BULLETIN NUMBER:
CB16-J-003

STOPPER BRACKET INSTALLATION – 16V-797

(Transport Canada – 2016-545)

- 2014-2016MY Isuzu N-Series Vehicles
Equipped with 6.0L Gasoline Engines

Figure 1 – Tighten Accelerator Pedal

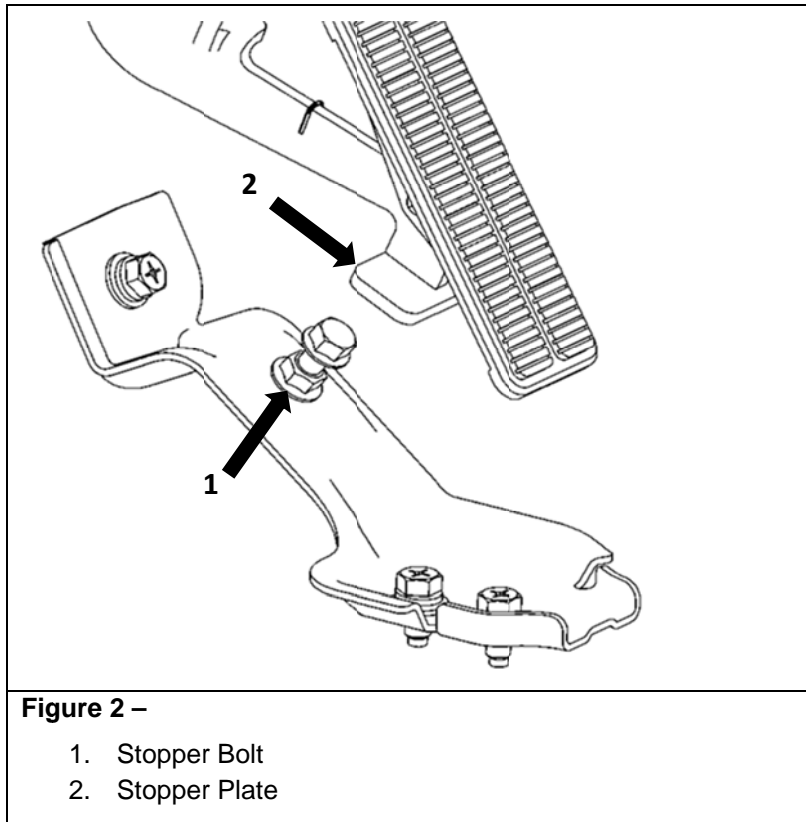
1. Set the parking brake, remove the key from the ignition and block the front wheels in a well-lit area.
2. Tighten the two (2) accelerator pedal mounting nuts (see Figure 1) to 18 Nm (13 ft. lb.).

Figure 3 – Temporary Bracket Installation

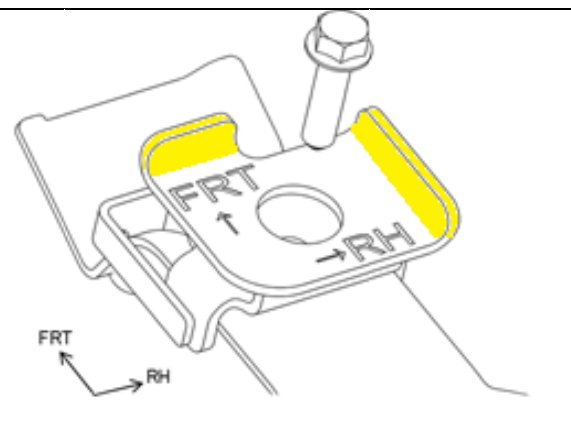
4. Temporarily install and hand tighten the new stopper bracket using the new bolt provided (see Figure 3). When tightened (even by hand), the head of the new mounting bolt should be below the flat surface of the new stopper bracket. Be sure the stopper bracket is aligned properly (see Figure 4).

Figure 5 – View From Right Side

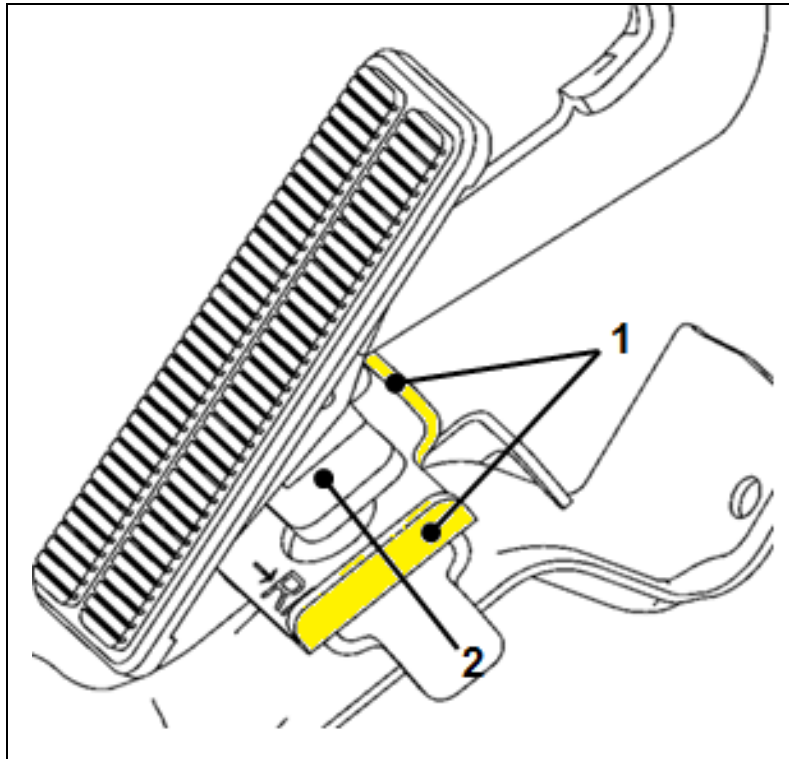
5. Depress the accelerator and ensure the stopper plate does not hit the flanged area of the stopper bracket (see Figures 5 and 6).

Figure 7 – View From Left Side

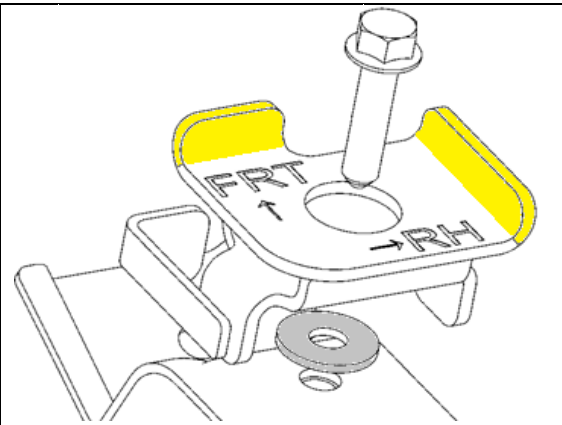
- a. If the stopper plate contacts the stopper bracket, torque the mounting bolt to **22Nm (16 ft. lb.) and go to Step 7.**
 - b. If the stopper plate does not contact the stopper bracket, check the clearance by depressing the pedal to WOT and attempting to insert one of the washers provided with the stopper bracket between the stopper plate and the stopper bracket (see Figure 7).

- i. If the washer does not fit between these two parts, the clearance between the stopper plate and stopper bracket is less than 2mm and no adjustment is necessary. Torque the mounting bolt to **22Nm (16 ft. lb.) and go to Step 7.**

Figure 8 – View From Left Side. Yellow indicates stopper bracket flange.

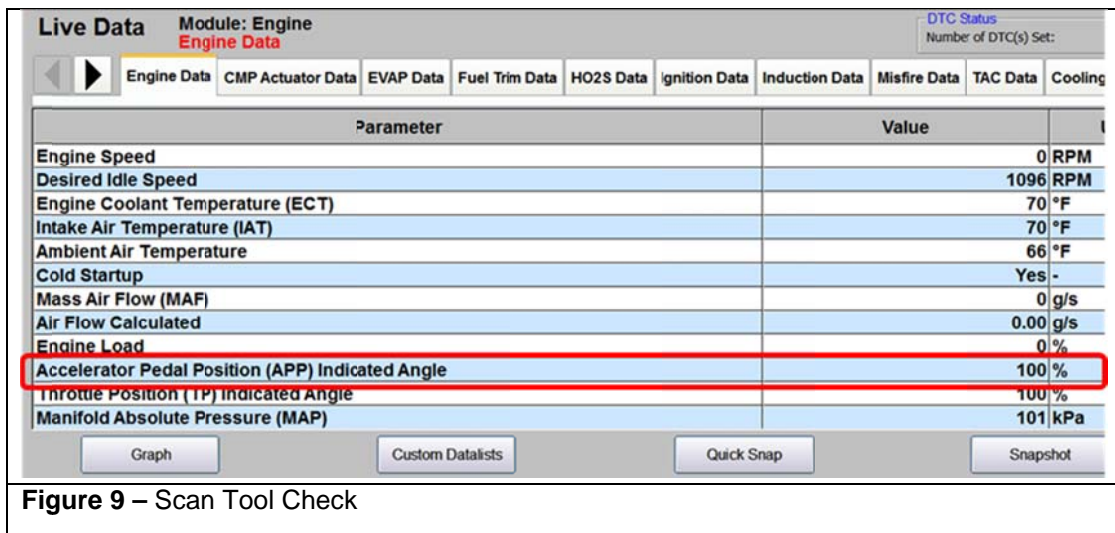
- ii. If the washer does fit between these two parts, remove the stopper bracket and add the washer between the stopper bracket and the floor (see Figure 8), and reinstall. This will adjust the clearance. Check the clearance again by repeating Step 6 with the second washer and follow the results.
